## SITE INSTRUCTION

PROJECT: HAMPTON MANOR  
25 BAKER HILL BLVD  
STOUFFVILLE, ONTARIO

SITE INSTRUCTION: E-11

**Purpose:** To suit metering requirement.

### 1.0 Reference Drawing E-10 (Riser Diagrams) Issued

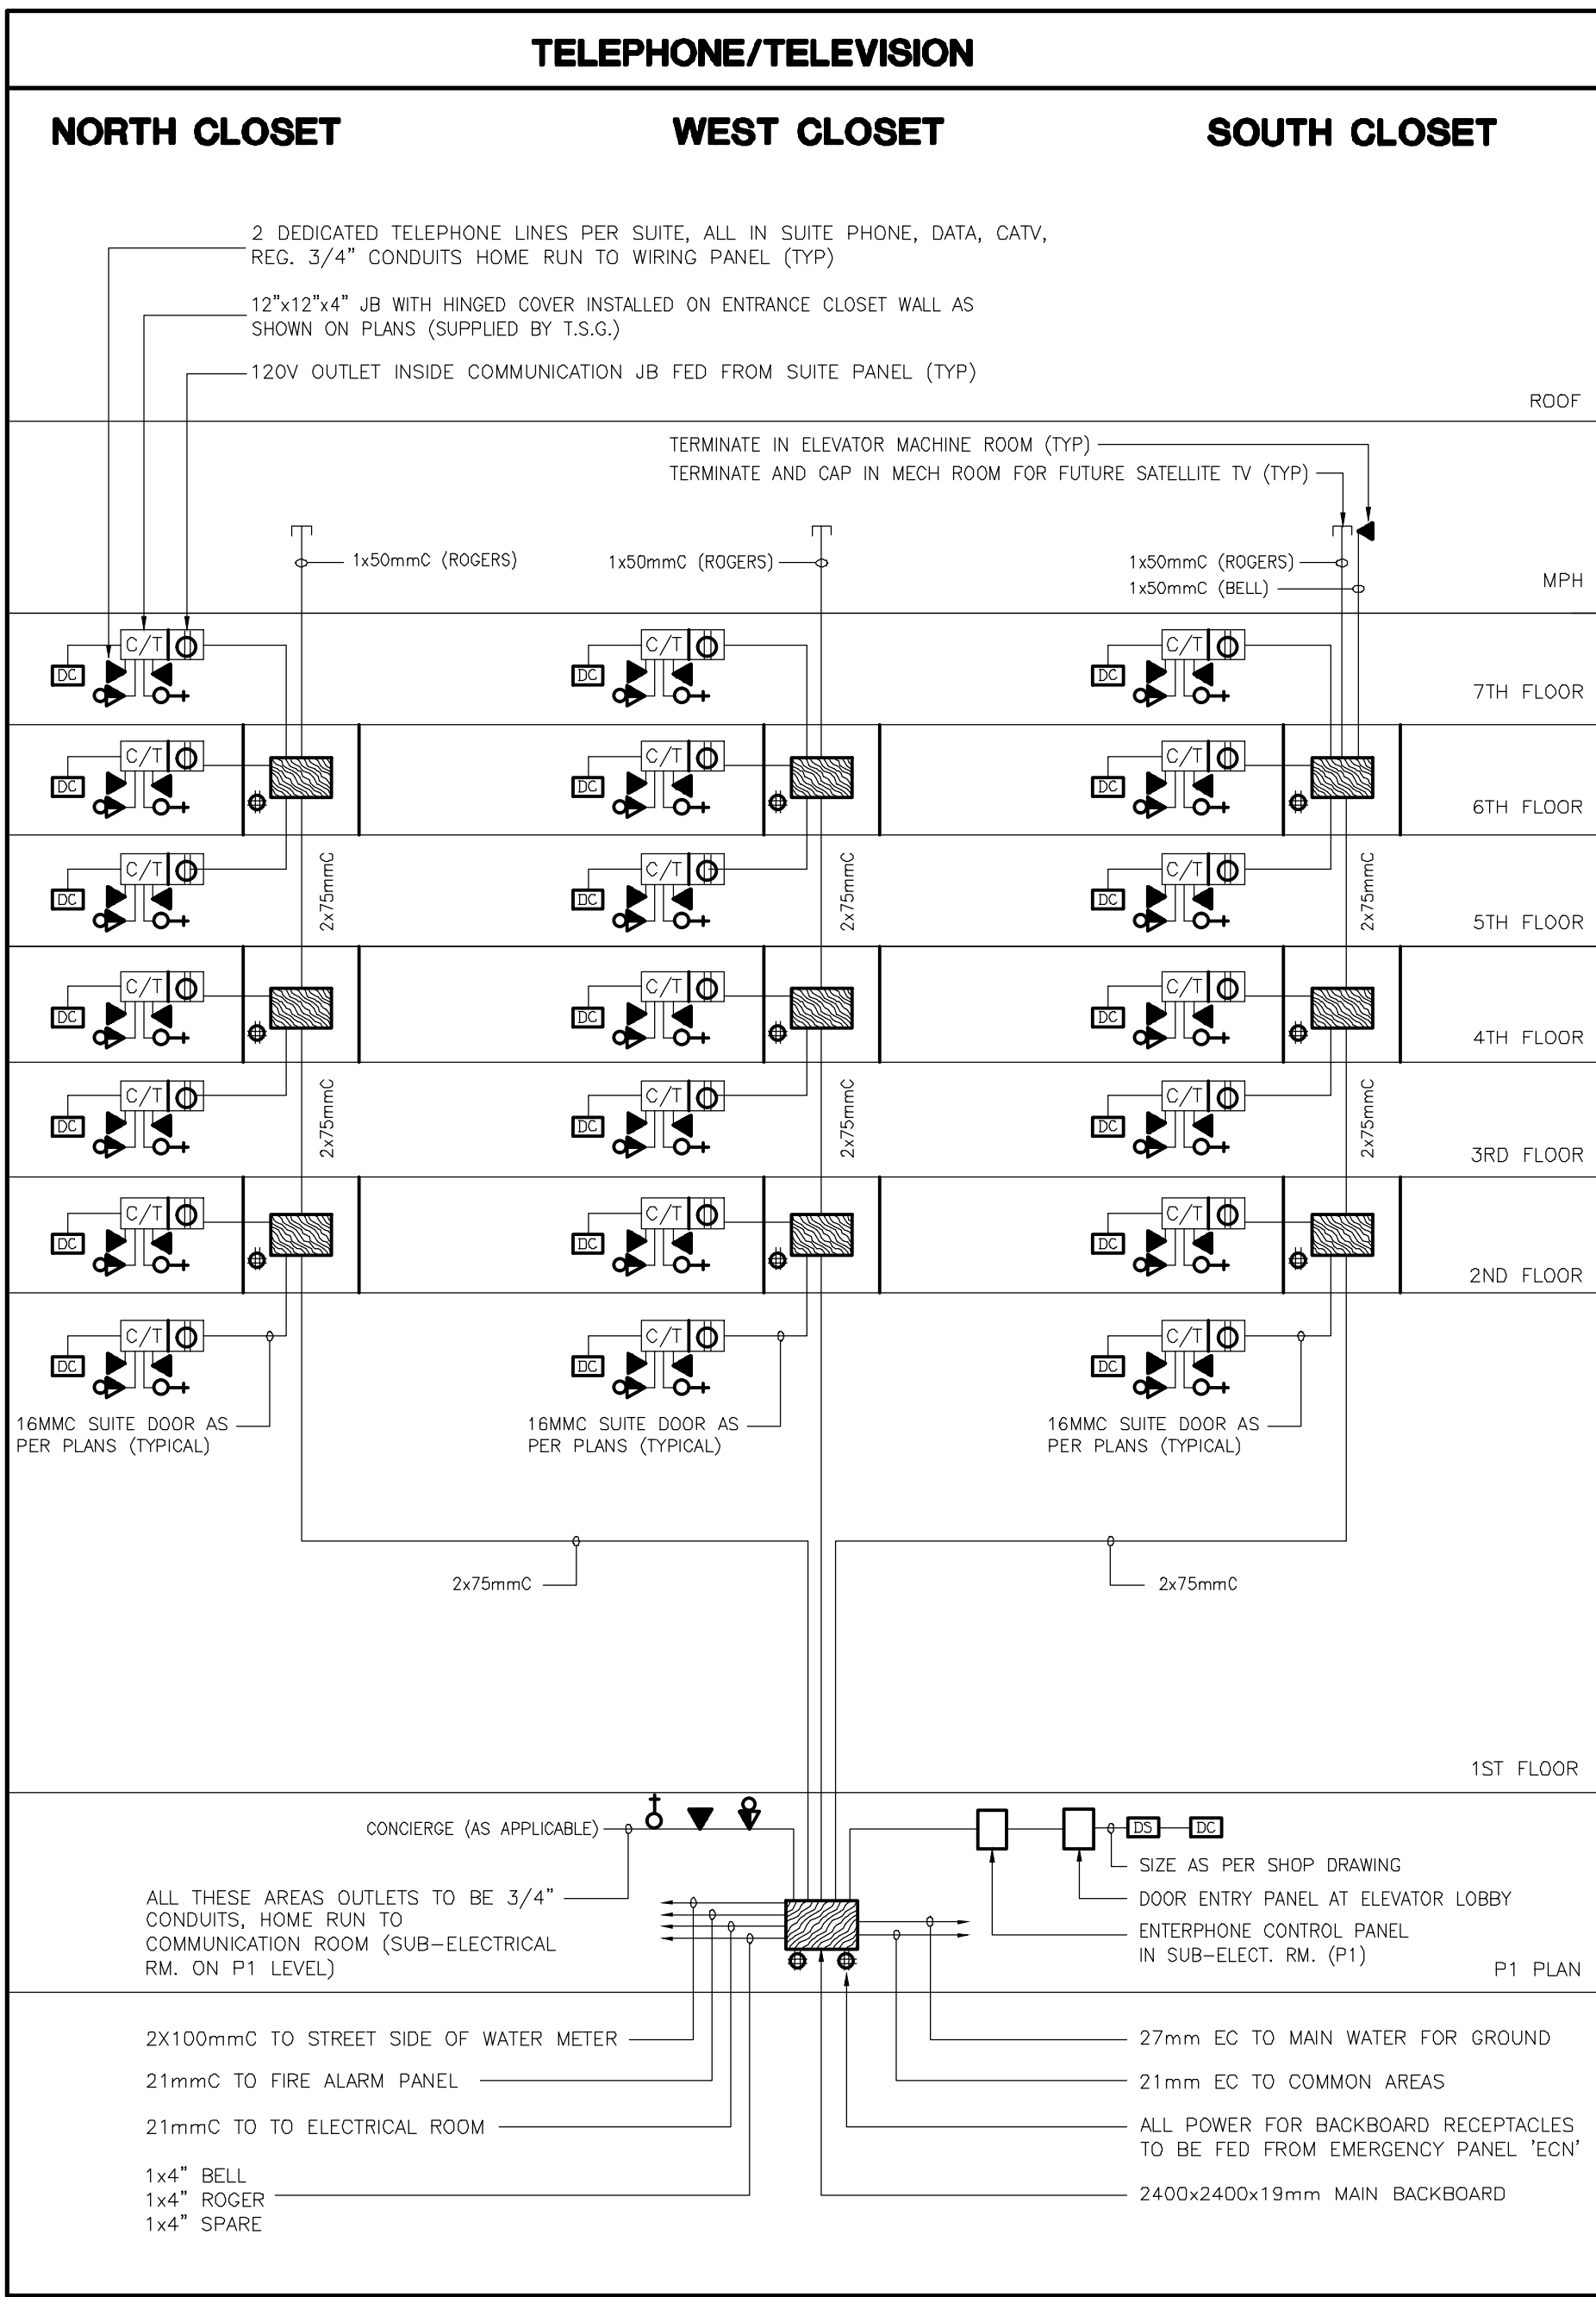
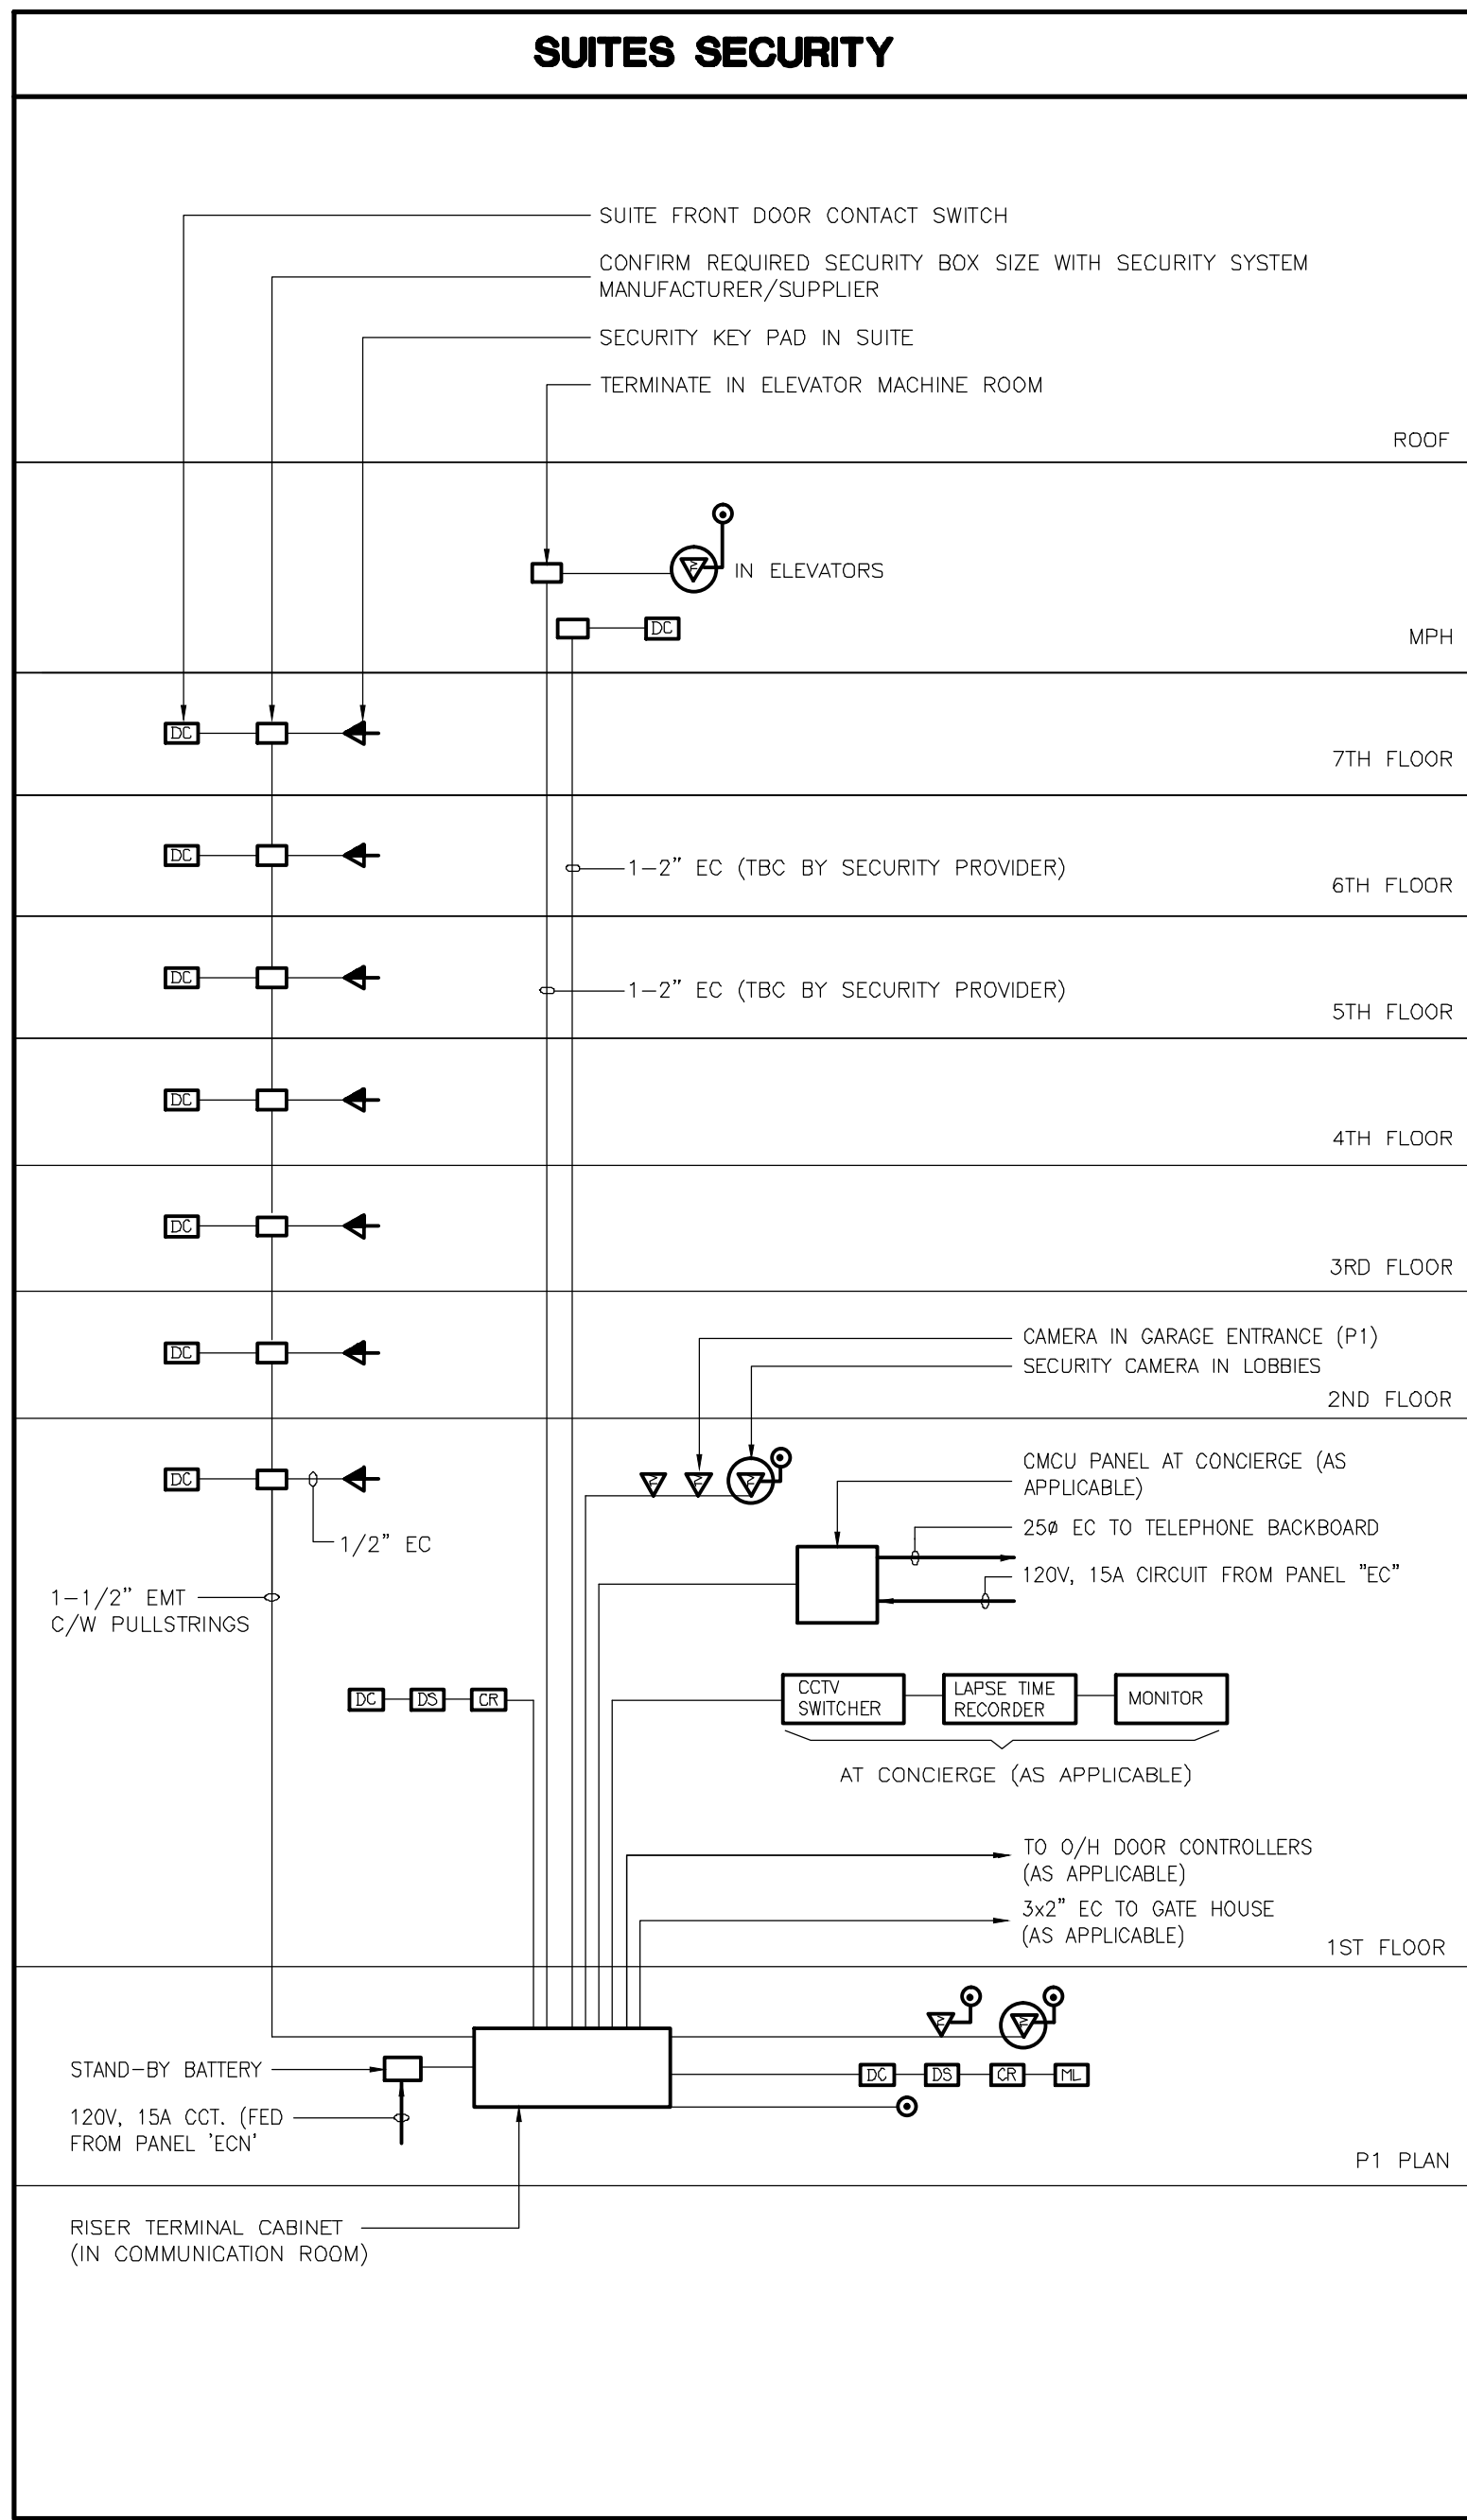
1.1 Add: 15A, 3P breaker receptacle for each quadlogic meter.
